FAIRFAX COUNTY

STAFF REPORT

APPLICATION RZ/FDP 2000-MV-019

**WASHINGTON HOMES
AT
SILVERBROOK ROAD
MT. VERNON DISTRICT
FAIRFAX COUNTY, VA**

EXISTING SLOPE PROTECTION/ DRAINAGE EXHIBIT

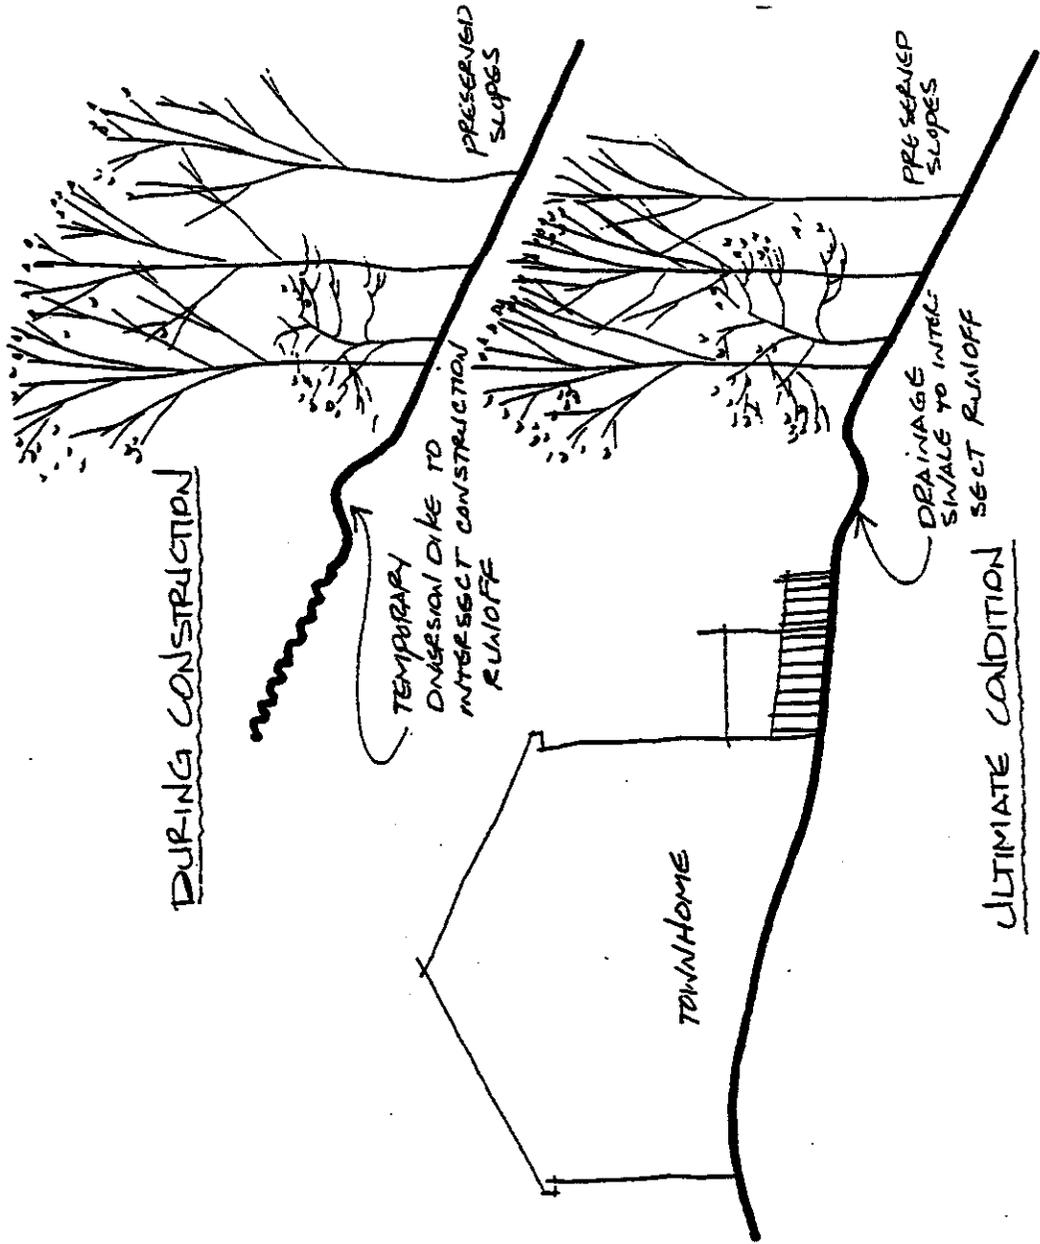
The steep slope areas are currently relatively stable due to the presence of mature vegetation (predominately a sub-climax beech-oak-tulip poplar forest). The Comprehensive Plan for the Lorton South-Route 1 area discourages development on steep slopes (greater than 15 percent), areas of low bearing strength, areas of marine clay and other unstable soils, and areas of high erosion potential. Staff recognizes that disturbance of some slopes greater than 15% is unavoidable due to the large acreage of such slopes on this site. However, the disturbance of the steep slopes should be minimized.

The revised CDP/FDP designates an area of the steepest slopes along the eastern face of the north to south ridge that overlooks I-95 as "Preservation Area." This area is the watershed for the wetlands discussed below. With this change, a large proportion of the most sensitive steep slopes is to be preserved. However, the future disposition of this property must be clarified. Staff recommends that the property be dedicated to the County as parkland.

This issue has been adequately addressed with the revised CDP/FDP; however, the future disposition of the property should be clarified in the draft proffer statement.

**COLLECTOR ROAD
 PLAN AND PROFILE**

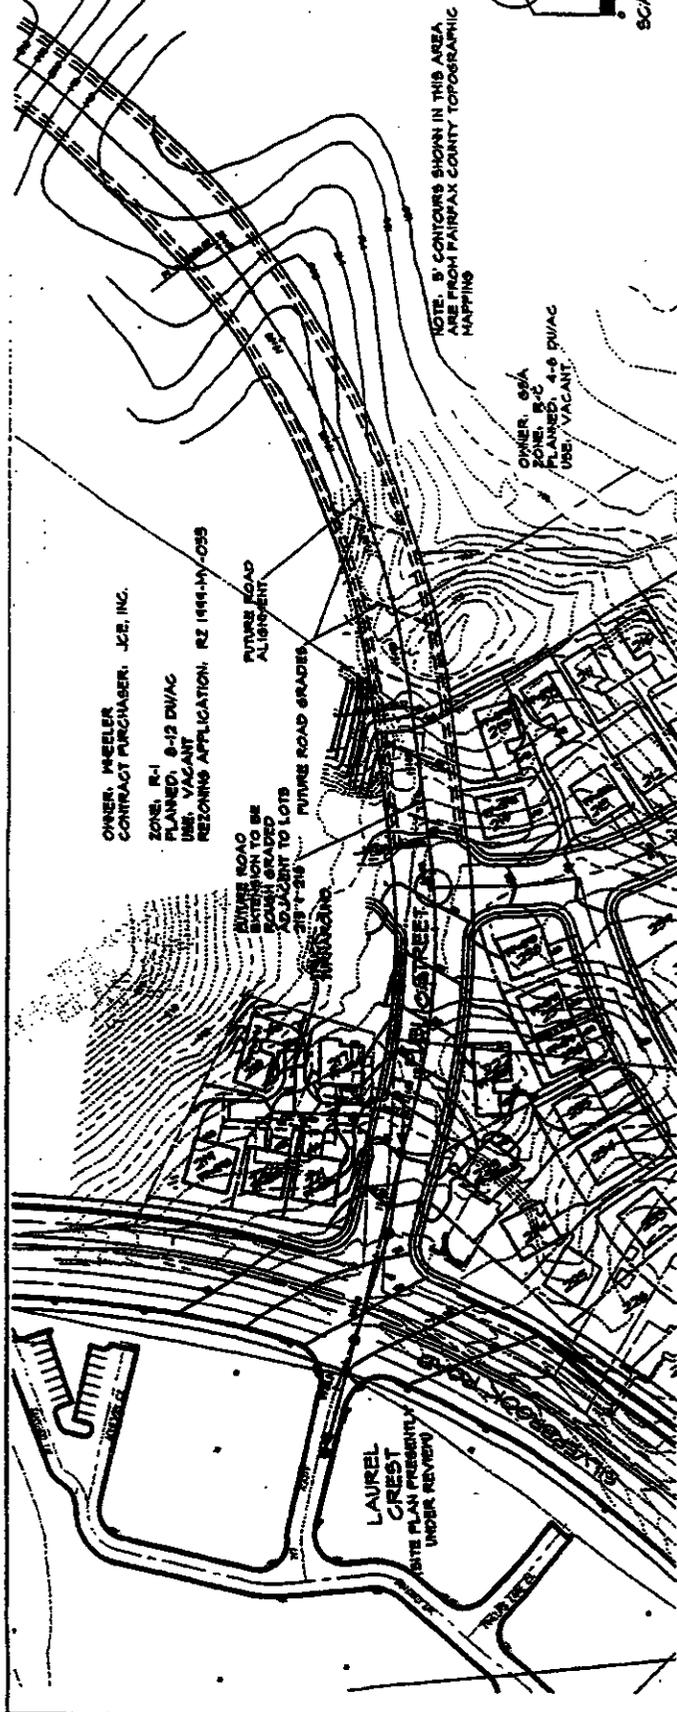
The detail on Sheet 8 demonstrates that the "Access Road" can be extended into the adjacent property. It shows that extensive grading will be required. Further, the CDP/FDP states that the road will be graded adjacent to the two affected lots, 215 and 216.

Sheet 8 of the CDP/FDP demonstrates that the "Access Road" can be extended to the adjacent property; however, extensive grading will be required. The sheet also notes that the final grade of the road will be established so that the nearest lots, Lots 215 and 216 will be based upon the final grade of the road.

The draft proffers should be modified to establish that the purchasers of the homes shall be provided written notice of the proposed extension of the roadway.
